Product Safety Recall

N202325160 Battery Cable Short Circuit

Revision: 01

Revision Description: This bulletin has been updated to include an inspection of the positive battery cable anti-rotation tab. Please discard all previous copies of N202325160.

5779103

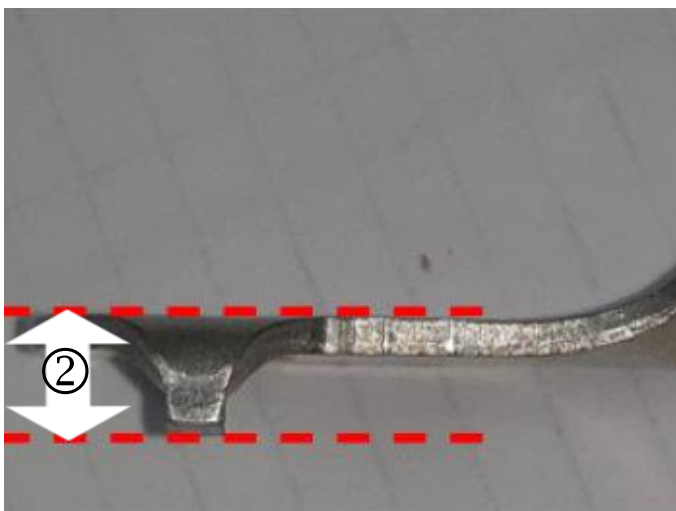
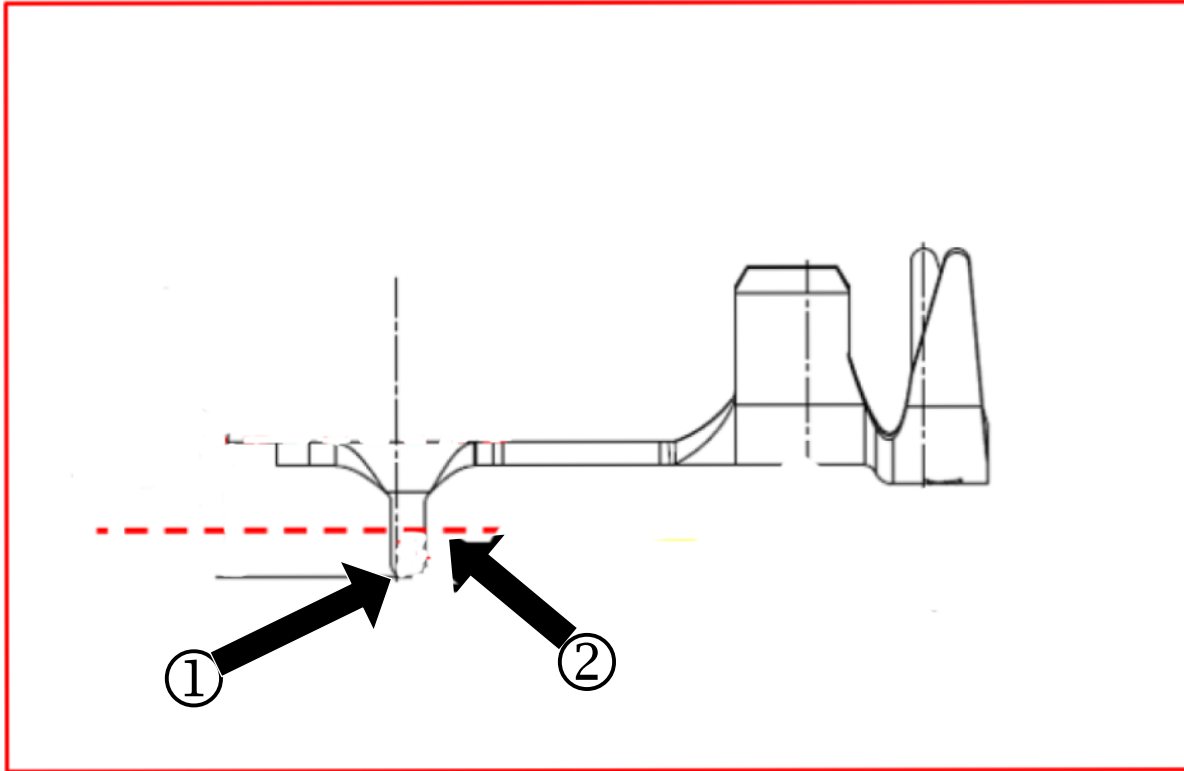
5. With the cables disconnected, locate the anti-rotation tabs on both cable ends.
6. Inspect the length of the terminal anti-rotation tabs on both cable ends.

- If one or both anti-rotation tabs has been cut completely off or is trimmed to less than 6mm in length (2), the battery cable assembly will require replacement. No service parts are available currently.
- If both anti-rotation tabs have not been cut, proceed to steps 7-15 below.

5779100

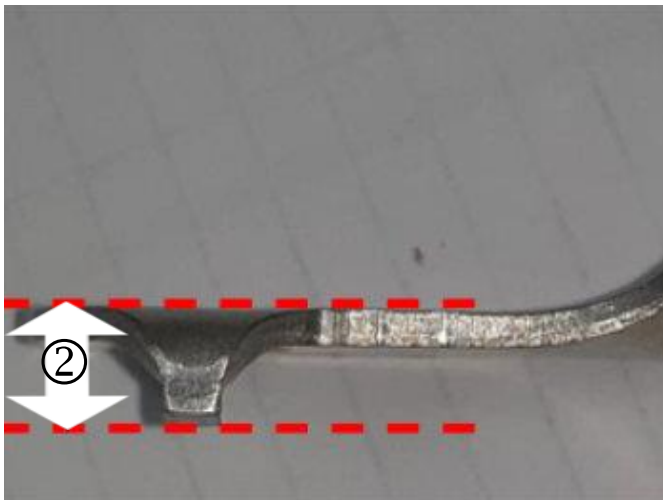
Important: The following measurement is critical to a correct repair. THE CUT MUST BE MADE IN THE EXACT LOCATION SHOWN IN THE GRAPHIC. DO NOT cut the anti-rotation tab flush. Cutting the tab flush may cause the cables to rotate and contact the fasteners or the Mega fuse mounting studs.

7. Starting from the bottom of the tab (1), measure up 4.5mm (2) from the end of the tab and scribe a line.

5779103

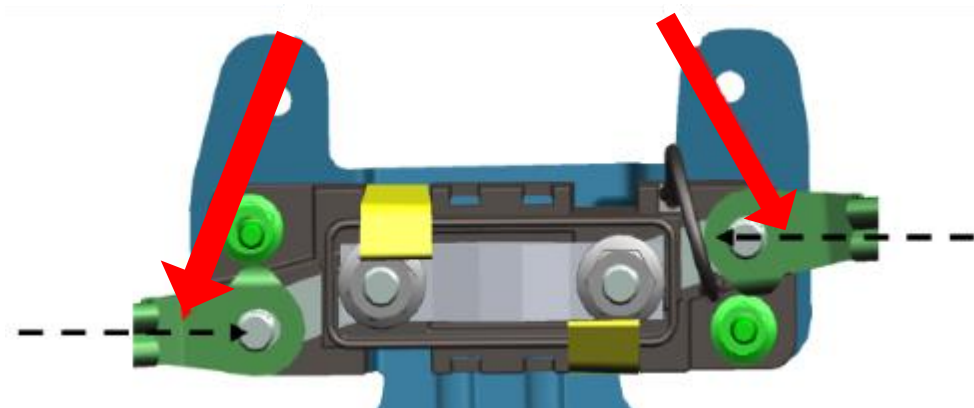
- Using cutters, cut on the scribed line. Use care to only remove the correct amount of the tab. DO NOT remove the complete tab.

- The completed trimmed terminal should have a total height of 6mm (2).
- After the tab is cut, ensure the tab is 90 degrees to the lug. Adjust as required by slightly bending the tab.
- Repeat the above steps on the second cable.
- Loosely reinstall the two cables.

5779106

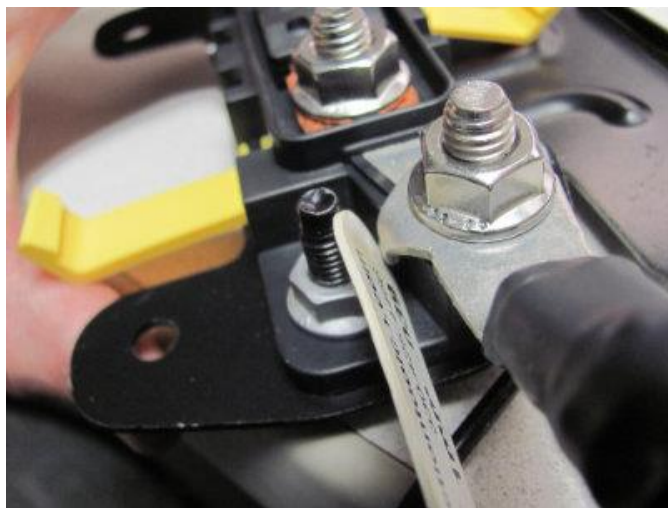
IMPORTANT: With both fasteners tightened to specification, **make sure there is at least 1mm clearance** between the anti-rotation tab and the nut at both locations. If the clearance is less than 1mm, remove the cable and further trim the tab as required.
